Model Peruvian (42-8) Elev A

Kings Ridge Print Date:01-Apr-14 Colours Upgrade Report

Lot 11
Phase 3
Model Peruvian (42-8) Elev A CLAUDIO C. CALABRO

## 42-08 Peruvian – First Floor Changes

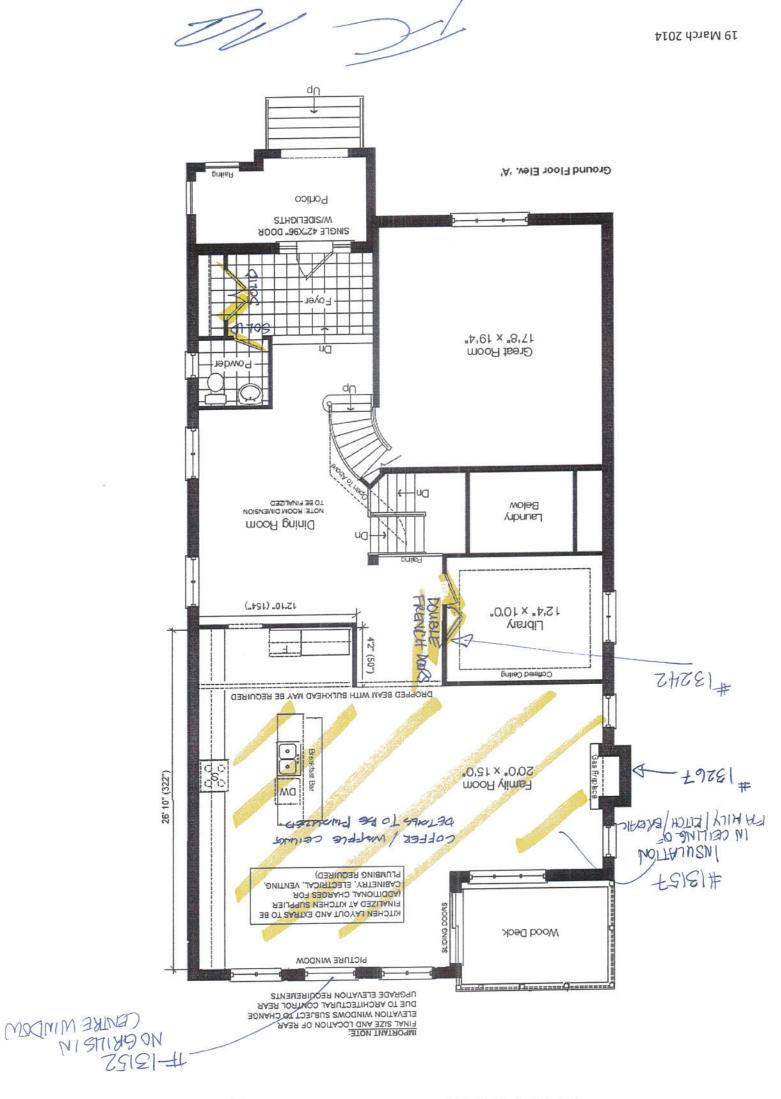
***Note: due to length of spans, structural supports will need to be installed within the layout and will be determined upon finalization of plans.		
-SEE 13153			2. Reconfigure coffer ceiling layout. All applicable sketches attached.		
+ <u>+</u> -		2183	<ol> <li>Delete servery area and lengthen Dining room by shifting dining room wall towards kitchen area.</li> </ol>	STRUCTURAL	11194
			All applicable sketches attached		
			determined.  4. Extend size of walk in closet in Master bedroom and reconfigure layout.		
		2183	<ol> <li>Bump-out rear corner of Kitchen and Master bedroom and square off 45 degree angled walls.</li> <li>Replace French exterior door with sliding patio door and transom. Size to suit opening.</li> <li>Due to rear upgrade condition the final rear wall window and door sizes &amp; locations are to be</li> </ol>	STRUCTURAL	11193
		2183	CEILINGS HEIGHTS - Increase finished ceiling heights  1. Main floor by 12 inches to be Approx be 10ft  2. 2nd floor to be 9 feet	STRUCTURAL	11192

## 42-08 Peruvian – Second Floor Changes

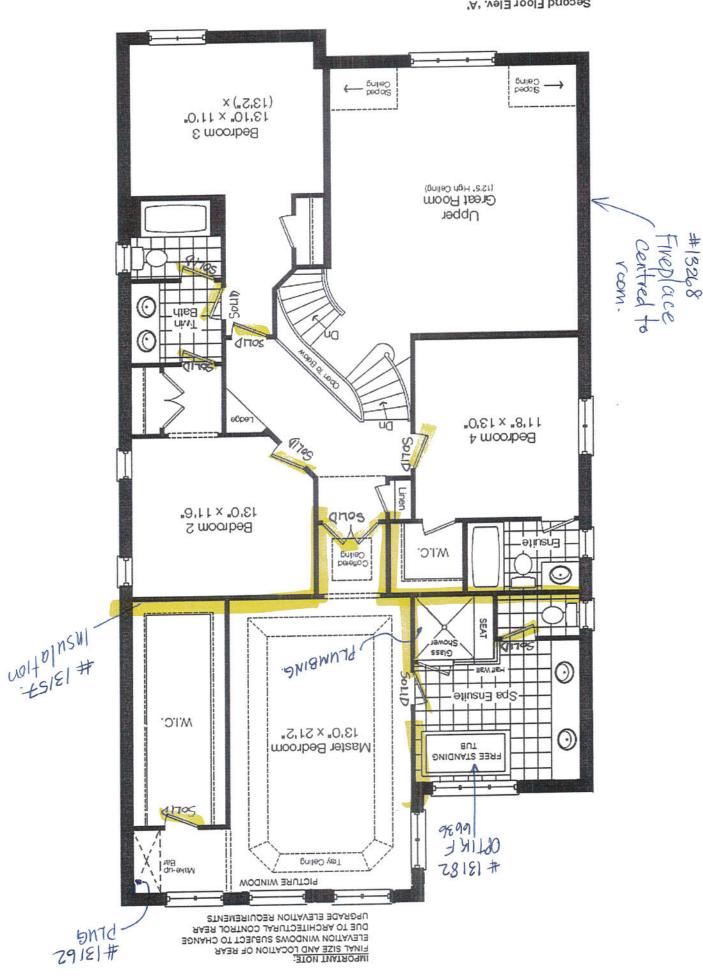
2561	All items above included in purchase price	STRUCTURAL	13270
2561	FIREPLACES - Heat activated fan kit for both fireplaces	STRUCTURAL	13269
2561	FRAMING / FIREPLACES ADD on Second floor great room - strap out wall from ceiling to floor and frame a box to accomodate CDVR33SC7 fireplace to sit flush.  **No Mantle, No marble  **Wall to be approximatey 10 feet wide by 12-13 inches deep  **Fireplace to be approximately 2-4 inches above finished floor  **Stone to be purchased at time of colours	STRUCTURAL	13268
2561	FRAMING / FIREPLACES in family room - strap out wall from ceiling to floor and frame a box to accomodate standard 36 inch fireplace to site flush.  **No Mantle, No marble  **Wall to be approximatey 6 feet wide, approx 8 inches deep  **Fireplace to be approximately 2-4 inches above finished floor  **Stone to be purchased at time of colours	STRUCTURAL	13267
